LATE REPRESENTATIONS

Committee PLANNING COMMITTEE

WEDNESDAY, 26 FEBRUARY 2020, 1.30 PM

LATE REPRESENTATIONS SCHEDULE PLANNING COMMITTEE – 26th FEBRUARY 2020

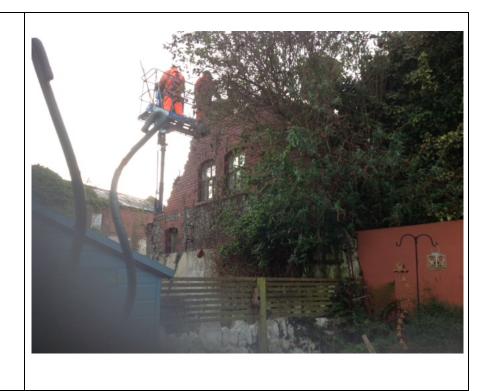
Vehicular trip generation to and from a residential site is likely to be tidal departing in the morning and arriving back in the evening primarily in line with working hour arrangements. As such to demonstrate the level of car parking which could be associated with the site the level of departure and arrival movements during the AM peak period of 0700-0900 and PM peak period of 1600-1800 have been assessed. This demonstrates that a maximum of 9 departures and arrivals occur in both peak periods of operation. To allow for some flexibility in arrival and departure movements the provision of 16 car parking spaces on the site is therefore considered to be sufficient to accommodate likely demand associated with the residential development.

Noted

The proposals have been assessed by the OM Transportation. No objections are raised, subject to conditions and a legal agreement.
